City of Somerville

ZONING BOARD OF APPEALS

TO: Planning Board
FROM: OSPCD Staff
SUBJECT: 59 Bow Street, ZP24-000098 (Major Amendment to Special Permit),
ZP24-000099 (Major Amendment to Site Plan Approval)
POSTED: August 27, 2025

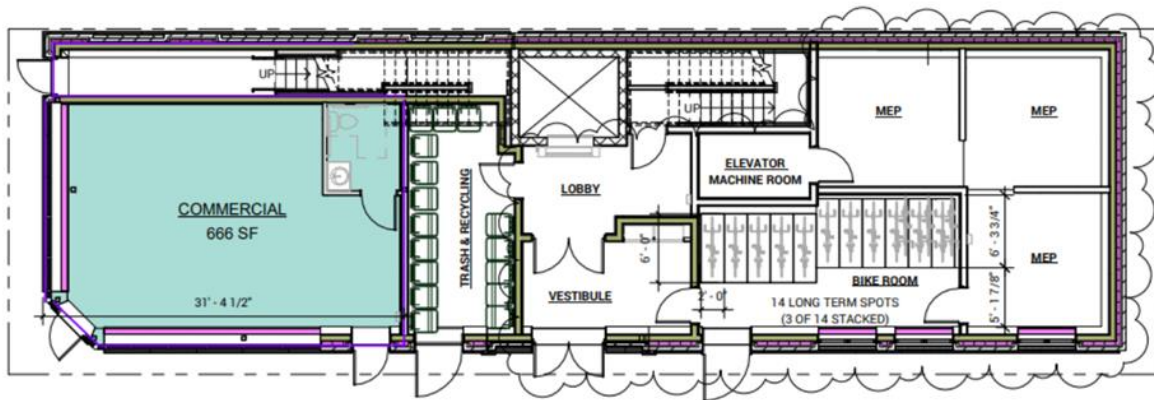
- The first-floor floorplan was rearranged to increase the space provided for the proposed commercial/restaurant area and decrease the amount of mechanical space. The bicycle storage room was also rearranged in accordance with their most recent TAP.

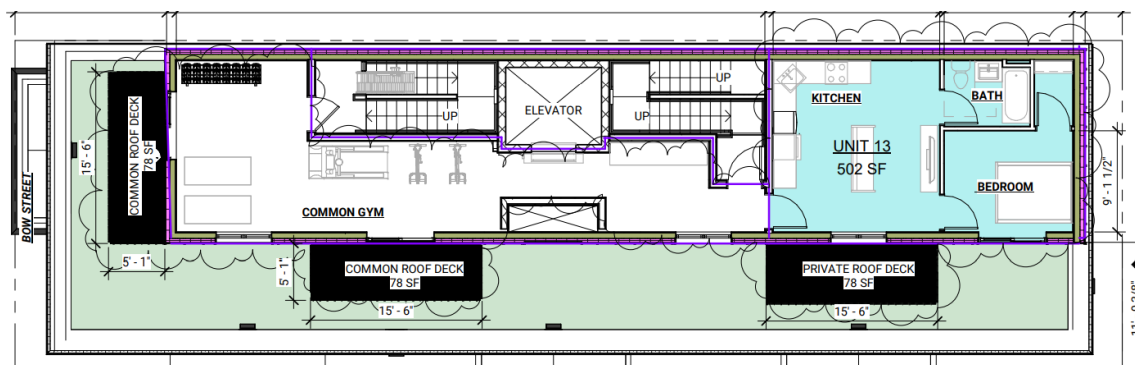
- Solid walls were added to the main entrance of the commercial space.

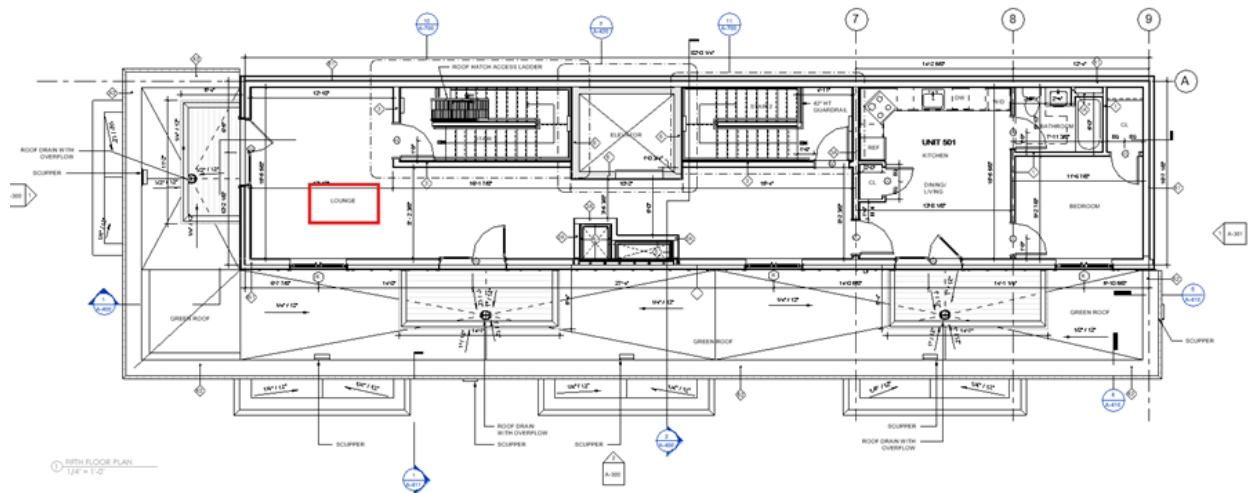
- The fifth-floor common space is now proposed as a lounge, rather than a gym.

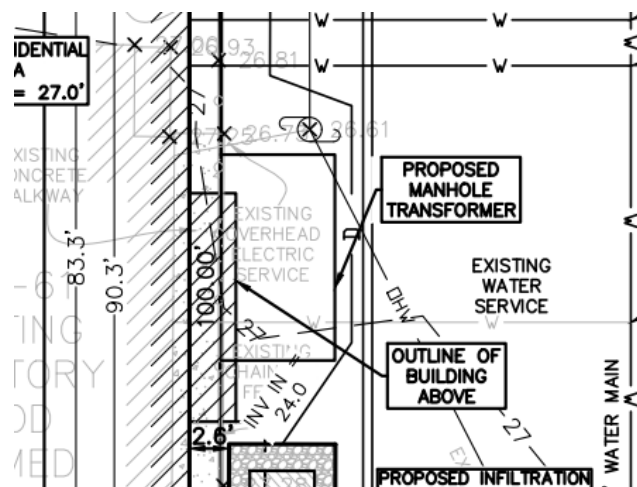
- An underground vaulted transformer is explicitly shown on the updated (July 30, 2025) plans. Previously (on the March 25, 2024 plans), a transformer was shown in the Bow Street Place frontage of the lot on renderings included in the architectural plans. This would have been a violation of the Zoning Ordinance, as this is a corner lot with two frontage areas (along both Bow Street and Bow Street Place). The underground transformer in the updated plans is in compliance.

In order to ensure that the construction of the transformer will be zoning-compliant, Staff suggests that *before* granting approval of the project, the Planning Board, require the Applicant provide a letter of intent from Eversource demonstrating that Eversource has agreed to an underground transformer in this location.
